Access Compliance Report

Public Rights-of-Way

(Curb Ramps)

Intersection ID: 7084	Main Street: CEDARHURST_DR	Cross Street: DALECREST_DR	Location: S
ADA ID: BEA2002252A0	Ramp Type: Perp	Initial Pass/Fail: Fail	Overall Compliance: No
Severity Score: 42.5			
Codes/Mitigation Info/Possible Solution		Field Measurements/Component Compliance

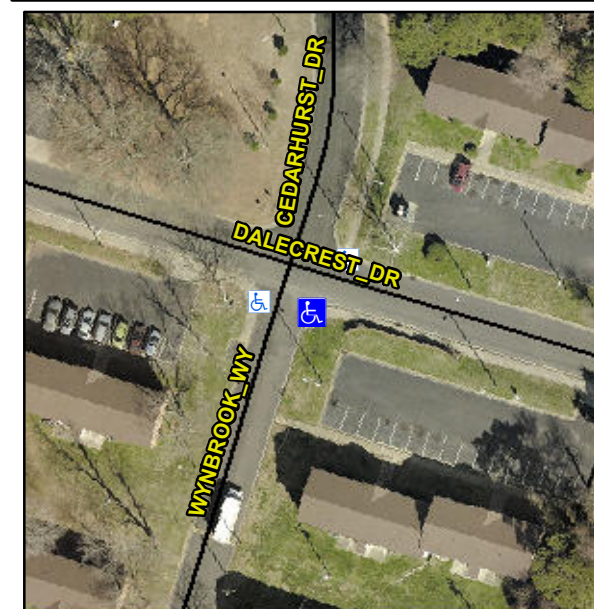
Not Found, R304.5.1, R304.2.2

Compliance	Description	Data	Compliance	Description	Data
N/A	Ramp Length (in)	61.0	No	Ramp Slope (%)	12.1
No	Ramp Width (in)	32.5	Yes	Ramp XSlope (%)	0.8
N/A	Flare Type LT	N/A	N/A	Flare Type RT	N/A
N/A	Flare Slope LT (%)	N/A	N/A	Flare Slope RT (%)	N/A
N/A	Flare Traversable LT?	N/A	N/A	Flare Traversable RT?	N/A
N/A	Landing Length (in)	N/A	N/A	DWS Provided?	N/A
N/A	Landing Width (in)	N/A	N/A	DWS Contrast?	N/A
N/A	Landing Slope (%)	N/A	N/A	DWS Length (in)	N/A
N/A	Landing X Slope (%)	N/A	N/A	DWS Full Width?	N/A
N/A	Landing Curb? (Y/N)	N/A	N/A	DWS Offset (in)	N/A
N/A	Shared Landing?	N/A			
N/A	Gutter Ponding?	N/A	N/A	Gutter Slope (%)	N/A
N/A	Gutter Lip Ht (in)	N/A	N/A	Gutter X Slope (%)	N/A
N/A	Painted X Walk1?	No	N/A	Painted X Walk2?	N/A
	X Walk 1 Direction	To NW		X Walk 2 Direction	N/A
N/A	X Walk 1 Width (in)	N/A	N/A	X Walk 2 Width (in)	N/A
	X Walk 1 Slope (%)	0.5		X Walk 2 Slope (%)	N/A
	X Walk 1 X Slope (%)	1.8		X Walk 2 X Slope (%)	N/A

Remove & Replace Entire Ramp.
